RESPONSES in red

KNOX AND AMERICAN II

TITLE SHEET
DRC-Title

FLOOR PLANS
DRC-1.1

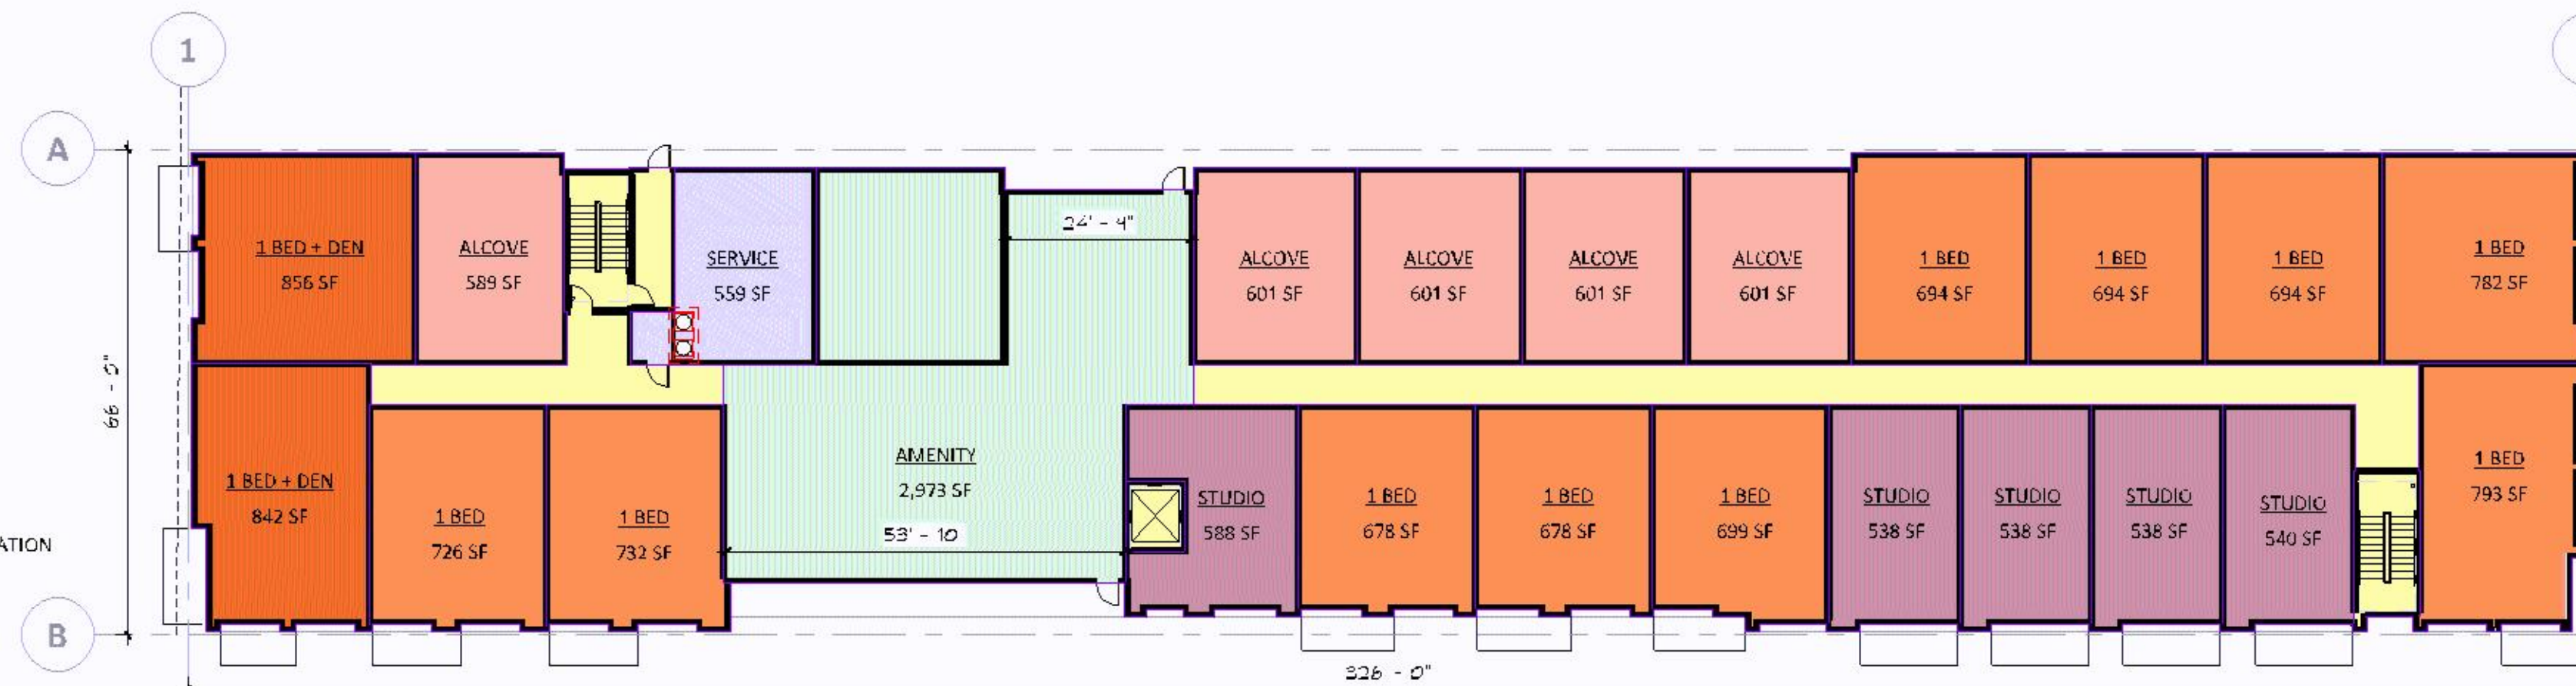
This can be discussed at the 80% plan review meeting.

Must meet 2020 MN State Building Code

Building plans must be signed by a MN licensed architect.

SAC review by MET council will be required.

Provide a detailed code analysis with the plans.

Must meet 2020 MN Accessibility Code.

The combination of 34 storage lockers and 22 stall storage boxes meets the City Code storage unit requirement when taking the OHO incentive into account.

Two level II or better EV chargers are required. This can be in the parking garage or on the surface lot.

RESPONSE:
 Acknowledged.

RESPONSE:
 Acknowledged to all.

RESPONSE:
 Acknowledged.

RESPONSE:
 Acknowledged.

BUILDING ELEVATIONS
DRC-2.1

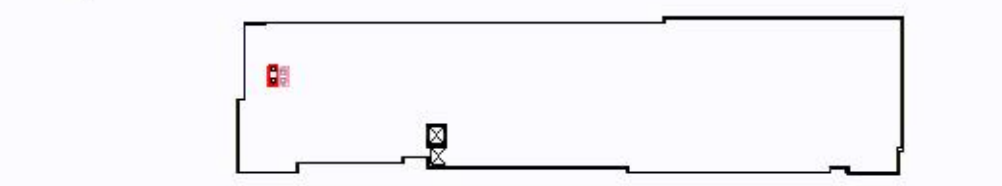
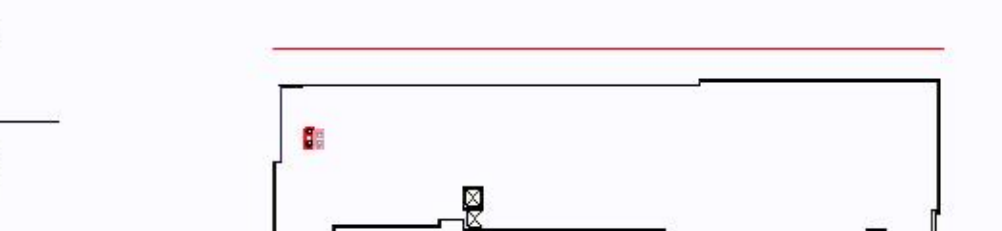
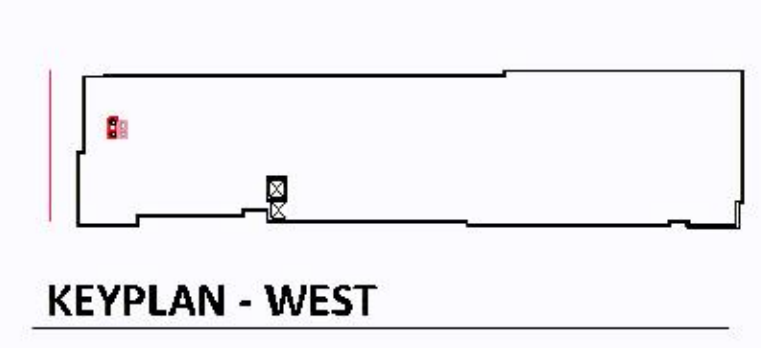
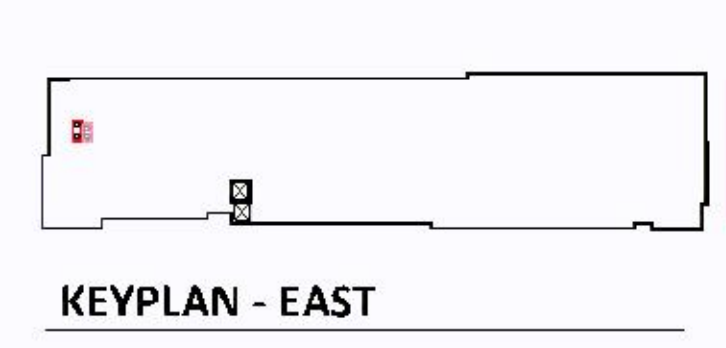
Provided the stucco and metal panel 5A meet City requirements the north, south, and east building elevations meet City Code requirements. The west building elevation would take advantage of the OHO exterior material incentive.

For the metal panel please ensure the panels have a minimum 30-year finish warranty. For steel panels, a minimum 22 gauge panel is required to be considered a "primary" material. The finish and gauge requirement does not apply to secondary panels.

Provide specification information for Prefinished Metal Wall Panel 5A, City staff is primarily concerned with metal panel finish warranty and panel gauge.

RESPONSE: See provided document "Metal Panel 5A BOD..." - this document includes the base specification we will use for this product.

RESPONSE: See provided document "Metal Panel 5A BOD..." - this document includes the base specification we will use for this product.
